Remarks/Arguments:

Applic. No. 10/699,134
Amdt. dated March 16, 2005
Reply to Office action of December 16, 2004

Fig. 1b
PRIOR ART

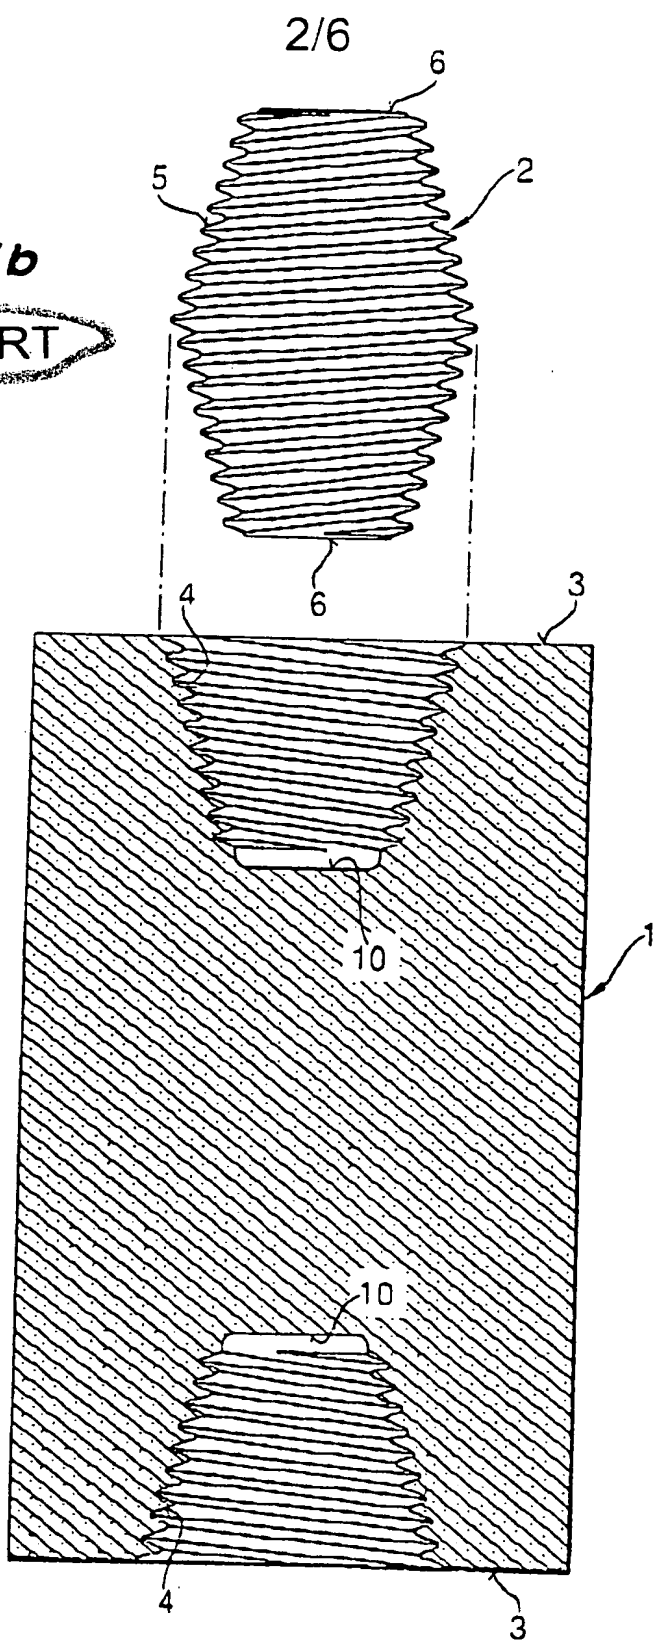
In the first paragraph on page 2 of the above-identified Office action, the Examiner stated that Figs. 1a, 1b, and 3a should be designated by a legend such as --Prior Art--. As noted above in the "Drawing Amendments" section, Figs. 1a, 1b, and 3a have been labeled "Prior Art".

The attached sheets of drawings includes changes to Figs. 1a, 1b, and 3a. These sheets which includes Figs. 1a, 1b, and 3a, replace the original sheets including Figs. 1a, 1b, and 3a. Figs. 1a, 1b, and 3a, are now designated as "Prior Art"

Please approve the drawing changes that are marked in red on the accompanying "Annotated Sheets Showing Changes" of Figs. 1a, 1b, and 3a. Formal "Replacement Sheets" of amended Figs. 1a, 1b, and 3a are also enclosed.
